# APPLICATION PROCESSING AND CALCULATIONS

PERMIT TO CONSTRUCT ANALYSIS (PC)

Eastern Municipal Water District 13088 Moreno Valley

DIGESTER GAS TREATMENT SYSTEM AND FUEL CELL POWER PLANT CONSISTING OF:

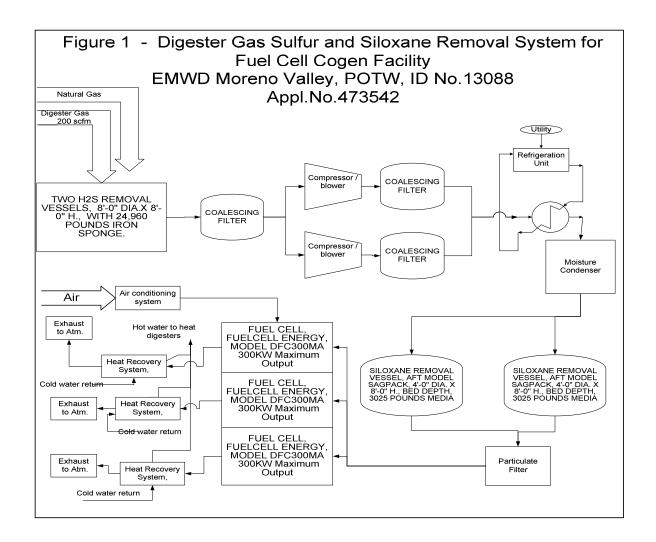
The digester gas treatment system is required to remove sulfur compounds and siloxanes from the biogas generated in the digester before the cleaned gas is consumed by a molten carbonate fuel cell. Figure 1 on the following page shows the configuration of the proposed gas treatment system.

The first step in the treatment process is sulfur removal. H2S is removed by passing the digester gas through a vessel filled with activated carbon impregnated with Fe2O3 (Iron Sponge). Each H2S removal vessel contains approximately 25,000 pounds of media with a removal efficiency estimated at 95%, which enables the system to reduce the concentration of H2S in the treated gas to less than 3 ppmv and below the maximum tolerance of 6.1 ppmv specified for the fuel cell. Then a particulate filter is used remove any entrained particles from the H2S adsorbent, and moisture before the flow is directed to a compressor. After the compressor, a refrigerated cooler, reheater, condenser, and demister is used to remove moisture before the gas stream enters the siloxane removal vessels.
